PURCHASING SECTION
13450 – 104 Avenue, Surrey BC V3T 1V8
Tel: 604-590-7274
E-mail: purchasing@surrey.ca
ADDENDUM #2

REQUEST FOR PROPOSALS (RFP) NO.:	1220-030-2017-025
TITLE:	SUPPLY, DELIVERY AND INSTALLATION OF ARTIFICIAL TURF – CLOVERDALE ATHLETIC PARK
ADDENDUM ISSUE DATE:	May 11, 2017
CLOSING TIME:	on or before the following date and time: May 12, 2017, 3:00 p.m., local time

GOAL POST MOUNTING DETAIL

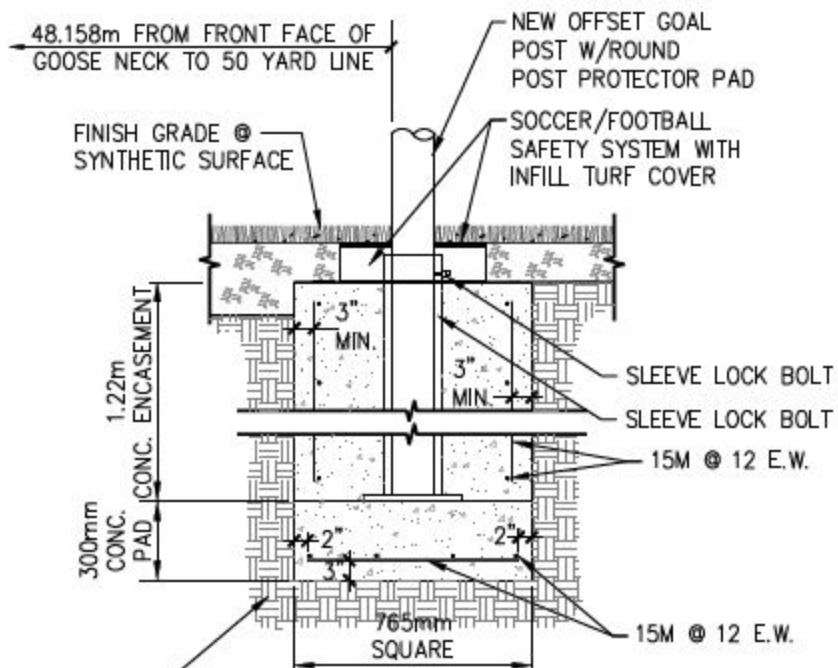
Q1: In Schedule A, item 1 General requirements, the scope of work for field #1, last item of the list is asking for the replacement of the existing football goal post. You have provided the expected model you want the bidder to work with in addendum 1. In appendix A.1 Performance specifications, page A.1-1, item 1.1.6. we are reading: "Remove the existing football goals and supply and install new football goals including foundations". We don't see any details in the drawings in regards of the expected goal post foundation. Question: is the foundation to be removed and replaced? If so, can you provide details on the foundation to build?

A1: The existing foundation is to be removed and replaced. Refer to the attached details on the foundation to build for the replacement of the existing football goal post.

SUITABLE APPROVED NON-ORGANIC SUBGRADE COMPACTED TO 95% MPD. EXCAVATION OF ORGANIC/UNSUITABLE MATERIAL & BACKFILLING WITH IMPORTED GRANULAR FILL OR APPROVED NON-ORGANIC EXCAVATED MATERIAL WILL BE REQUIRED.
(REFER TO GEOTECHNICAL REPORT FOR DETAILS)
